TECHNICAL REVIEW OF ROBERTS BANK TERMINAL 2 ENVIRONMENTAL ASSESSMENT: SECTION 9.5 – COASTAL GEOMORPHOLOGY

This Science Response Report results from the Science Response Process of July 2016 on the Technical Review of Ecopath with Ecosim and Ecospace (EwE) Ecosystem Productivity Model application to the Roberts Bank Terminal 2 Environmental Assessment. This is the first of two Science Responses developed to provide advice regarding the EwE model application.

Figure 1: TELEMAC-3D model domain (Port Metro Vancouver Environmental Impact Statement, Appendix 9.5-A, Figure 2. Used with permission).

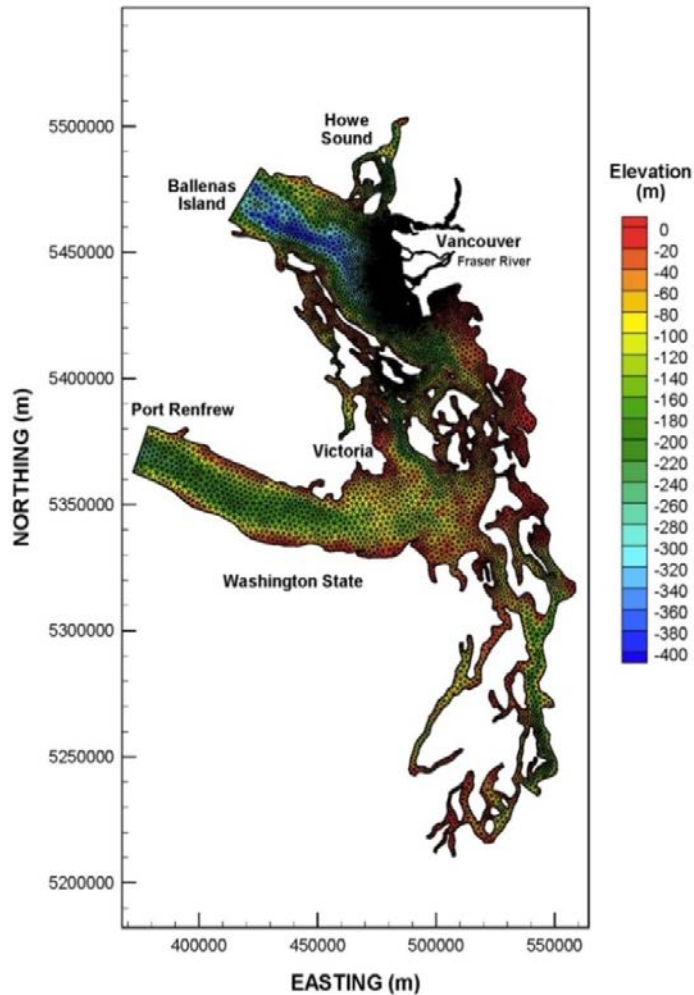
The model grid includes Juan de Fuca Strait (east of Port Renfrew), Puget Sound, the lower Fraser River (up to 36 km upstream of New Westminster), and the Strait of Georgia (south of Ballenas Island) (Fig. 1). The grid has 28000 nodes in the horizontal and 11 vertical levels. The horizontal resolution varies from 3 km in the Strait of Georgia to about 25 m in the vicinity of the project.

The TELEMAC-3D model is forced by the Fraser River flow at the upstream river boundary, and by tidal water levels from the main eight tidal constituents at the Port Renfrew and Ballenas Islands boundaries (see Fig. 1). Tidal levels at the open boundaries were obtained from the
